VIRGINIA WATER DRIVE EXT - PLAN-PROFILE
 WALLBROOK ROADWAY IMPROVEMENTS
 VIRGINIA WATER DRIVE EXTENSION (SERVING LOTS 9-11)
 Town of Rolesville Project No. CID 23-
 US 401 Business / S. Main Street & Virginia Water Drive
 Wake Forest Township, Town of Rolesville, Wake County, North Carolina

Project Manager: BCF
 Drawn By: DLT/TN
 Checked By: TN
 Project Number: 22049
 Drawing Number: D-1404-CID

ACCESS DRIVE - PLAN-PROFILE

C3.0

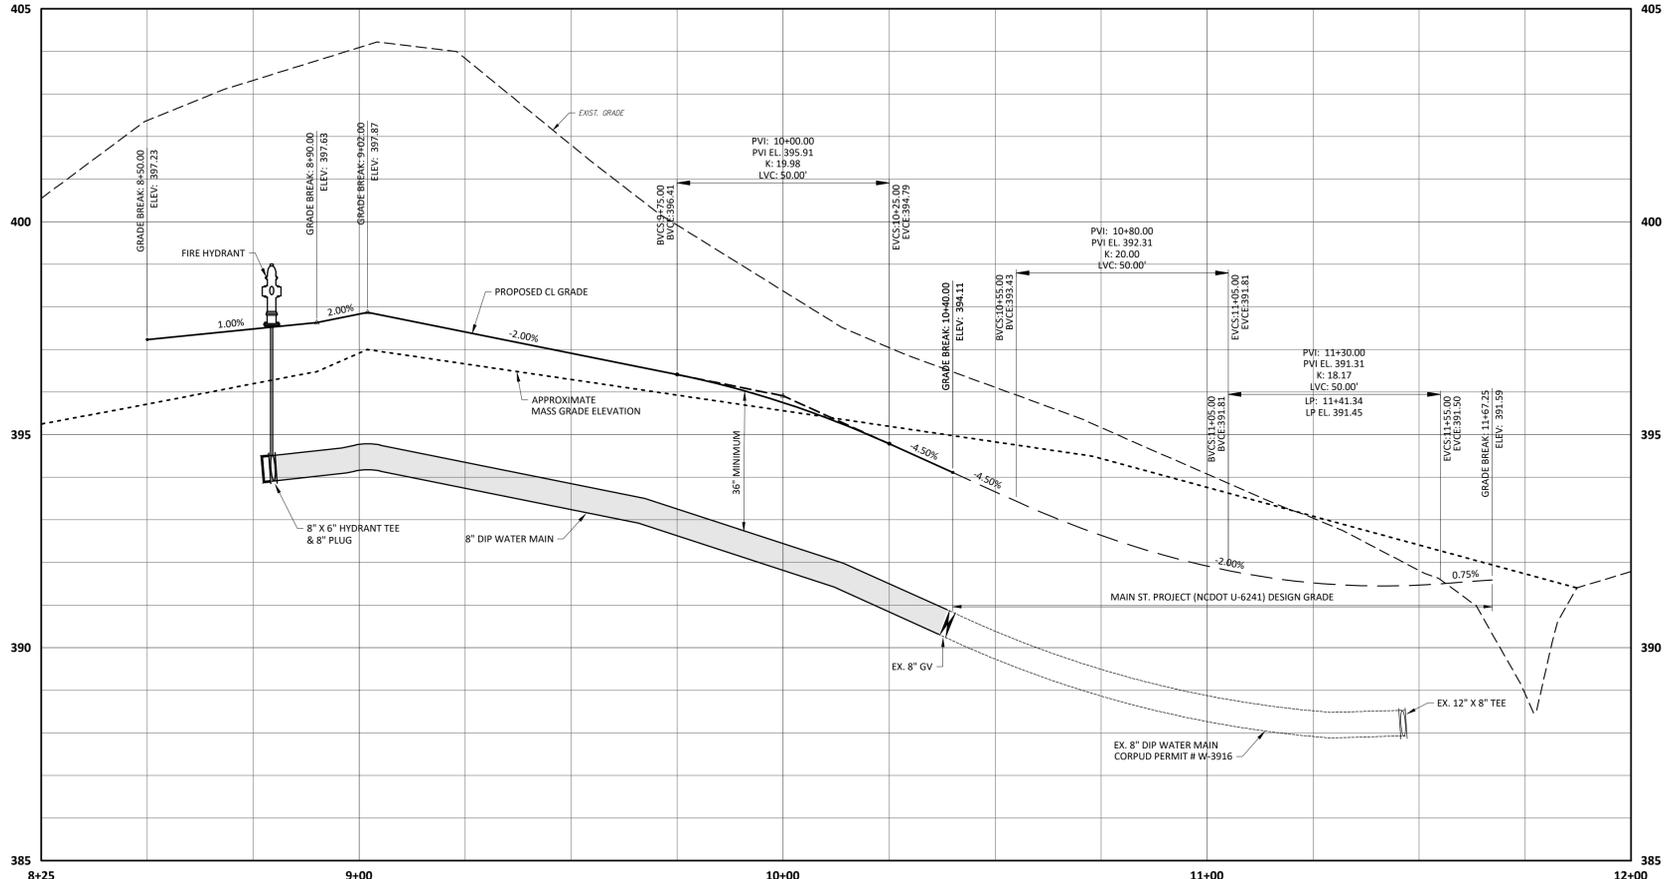
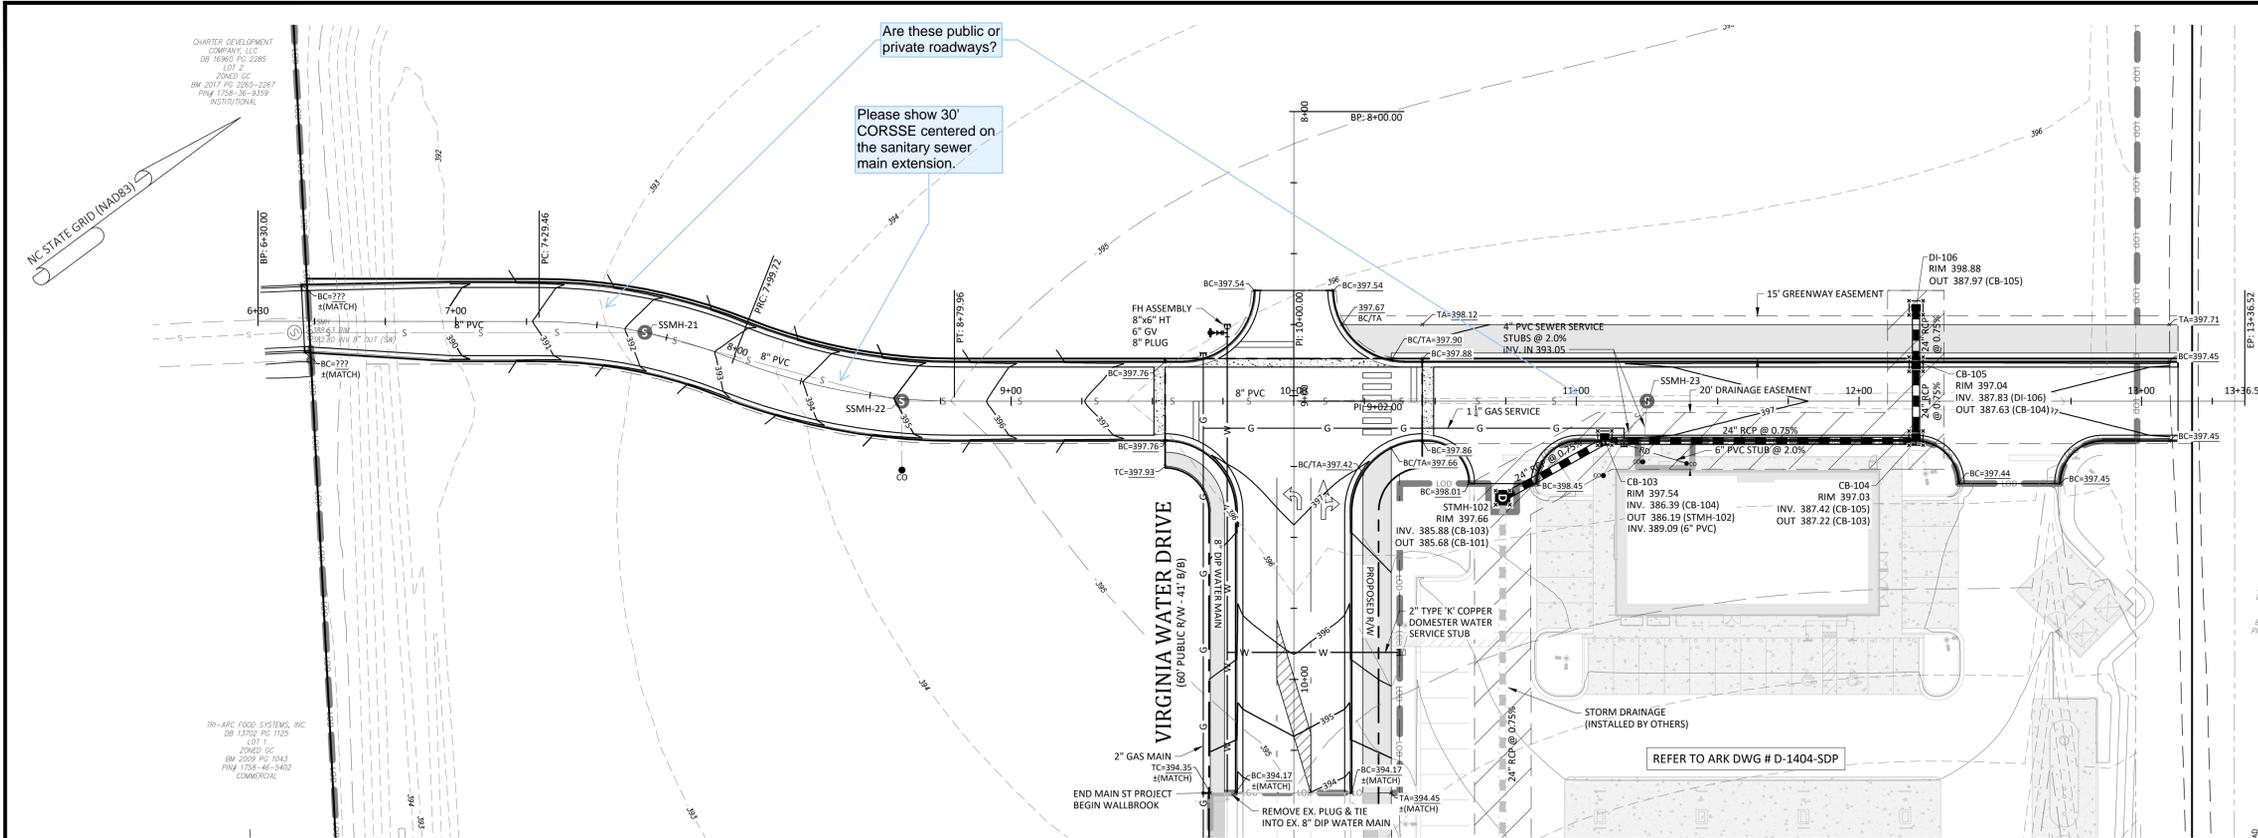
The waterline will need to terminate with a 8" blow off assembly. Also, CORWLE should be extended 5' on each side of the FH from the R/W.

The intent of these CDs may not be to subdivide these parcels but the master plan clearly shows a subdivision with 3 lots. Please clearly show the lots lines for all 3 of these lots so that it is demonstrated that all 3 will have access to public water and sewer. For example, if the east and west roadway extensions are private, you'll need to demonstrate that public sewer easement touches each parcel so that they will have access to sanitary sewer.

C3.1

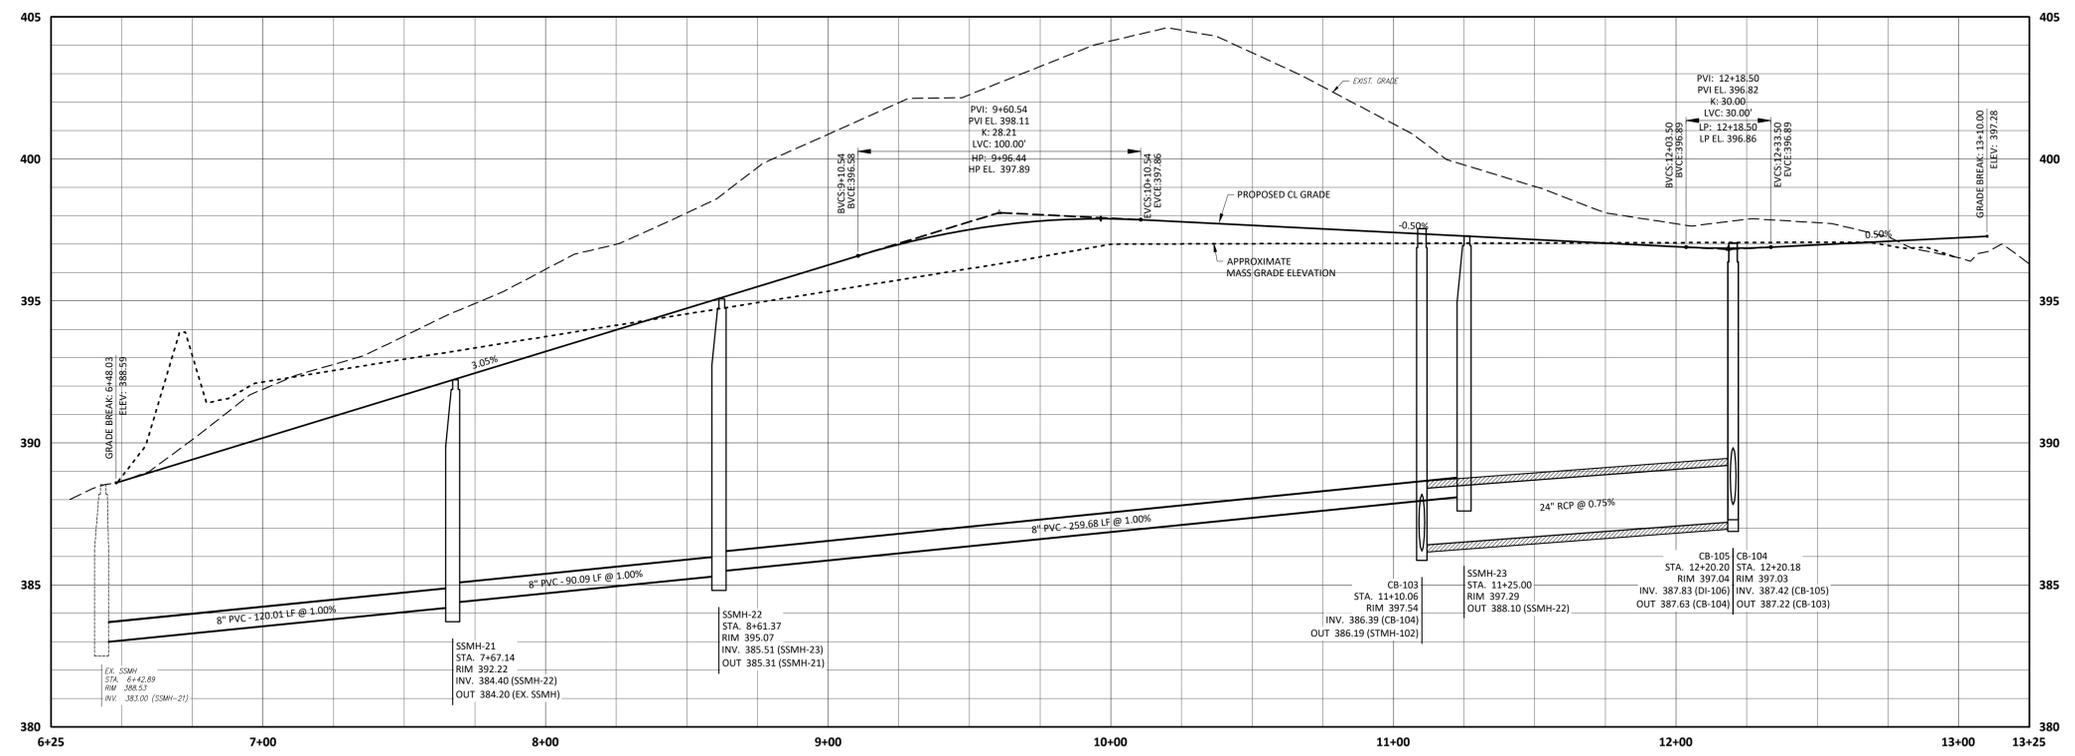
Are these public or private roadways?

Please show 30' CORSSSE centered on the sanitary sewer main extension.
